GLOBAL SAFETY FIELD INVESTIGATIONS
DCS6524
URGENT - DISTRIBUTE IMMEDIATELY

Subject: N222374570 - Customer Satisfaction Program
Incorrect U-bolt Torque Spec in Owner's Manual and Service

Models: 2019 – 2022 Chevrolet Silverado 4500/5500/6500 Medium Duty

N222374570 Incorrect U-bolt Torque Spec in Owner Manual and Service

Insert to the 2019 - 2022 Chevrolet Silverado 4500HD/5500HD/6500HD Owner's Manual

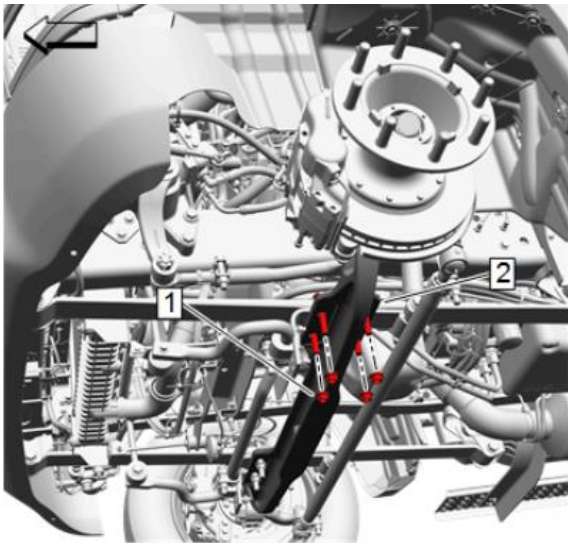
This information replaces the information under "Capacities and Specifications" found in the Vehicle Data Section of the owner's manual.

RPO Code	Front Suspension Type	Torque			
		4X4 N•m	4X4 lb-ft	4X2 N•m	4X2 lb-ft
FSN	3 600 kg (8,000 lb) Capacity, Spring Parabolic, Taper Leaf; with Shock Absorbers	235–265	173–195	162–185	119–136
FK6	3 100 kg (7,000 lb) Capacity, Spring Parabolic, Taper Leaf; with Shock Absorbers	235–265	173–195	162–185	119–136
F95	2 700 kg (6,000 lb) Capacity, Spring Taper Leaf, Shackle Type; with Shock Absorbers	235–265	173–195	162–185	119–136
FTV	3 400 kg (7,500 lb) Capacity, Spring Taper Leaf, Shackle Type; with Shock Absorbers	235–265	173–195	162–185	119–136
FTW	2 800 kg (6,250 lb) Capacity, Spring Taper Leaf, Shackle Type; with Shock Absorbers	235–265	173–195	162–185	119–136

4926468

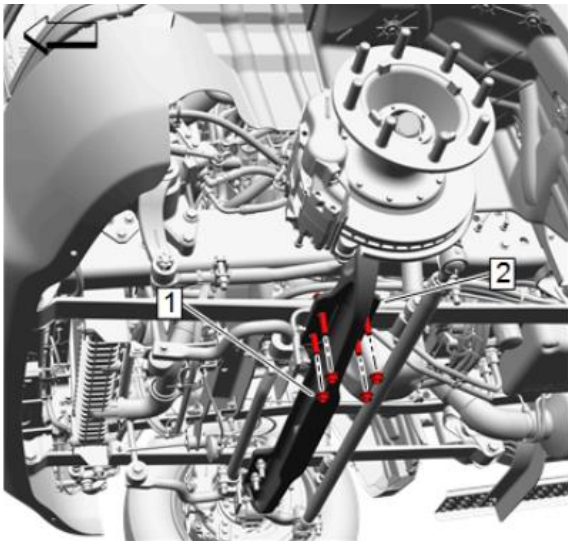
6. Using a digital torque wrench or equivalent set to 200 Nm (147 lb ft), verify all front spring U-bolt nut torques and do not exceed 162-185 Nm (119-136 lb ft).
 - If the torque values are within the specifications, proceed to step 13.
 - If the torque values exceed the specifications, proceed to step 7.
7. Support the front axle with an appropriate jack stand.

4926468

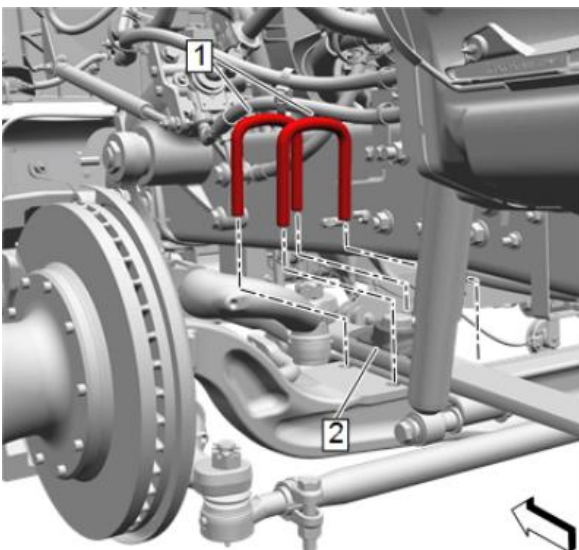
8. Remove and discard the U-bolt nuts (1) on the U-bolt that were over torqued.

4926469

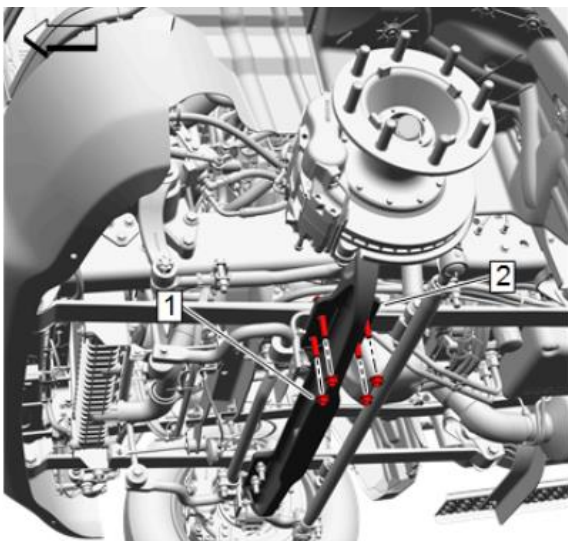
9. Remove and replace the U-bolt (1) that was over torqued.
